This document addresses several issues relating to Revision 13 of the SPI, Annex B (normative), SCSI Configured Automatically (SCAM).

All SCAM technical references are from Revision 13 of the SPI, Annex B (normative), SCSI Configured Automatically (SCAM).

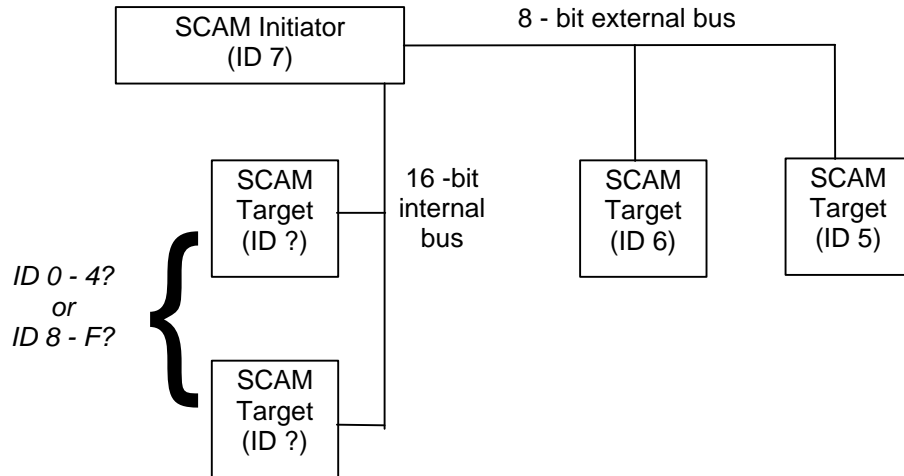
1. Annex B does not define timeouts for any errors that may occur during the protocol, such as:
 - during SCAM Selection, any of the control lines or data lines used for handshaking are never released by an initiator or target.
 - the second quintet of an action code is never received.
 - during the transfer cycles, a target or initiator never releases a handshake line (DB7-DB5).

These issues should be examined, and appropriate timeouts and recovery actions should be implemented. A suggestion is to use the SCAM selection response time (250ms). After this time has elapsed, the initiator(s) detecting the timeout should reset the bus. This solution is obviously too simplistic, but may serve as a starting point for discussions.

Example 1 - Single Initiator, mixed bus widths.

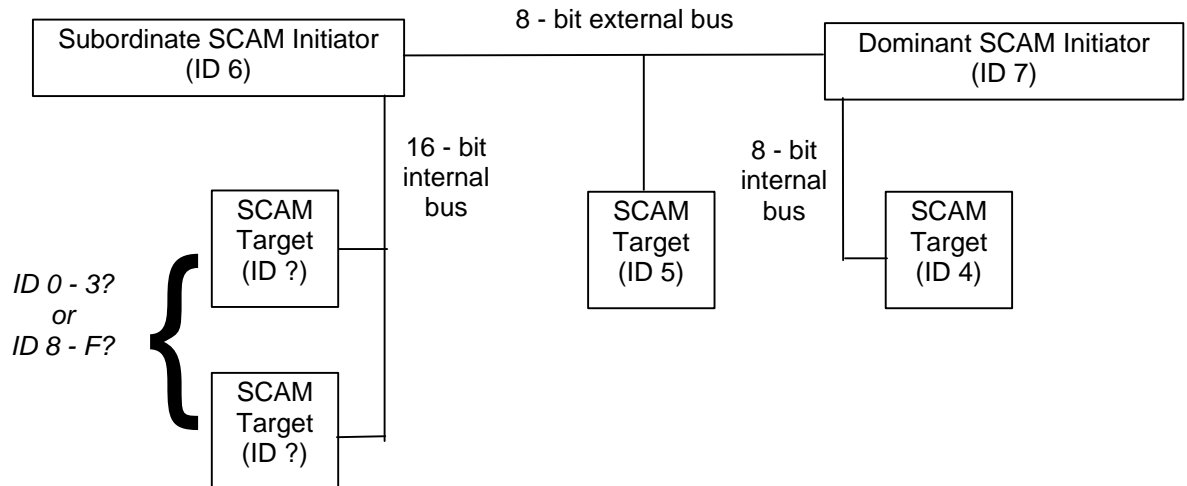
3. The area of ID assignment for mixed bus widths is not specifically addressed. Two diagrams below describe such situations. The first example is a 16-bit bus internally (with devices that will support a 16-bit bus), and an 8-bit external bus. The second example describes a multi-initiator system with mixed bus widths.

Question: Do the devices on the 16-bit bus receive IDs greater than 07?
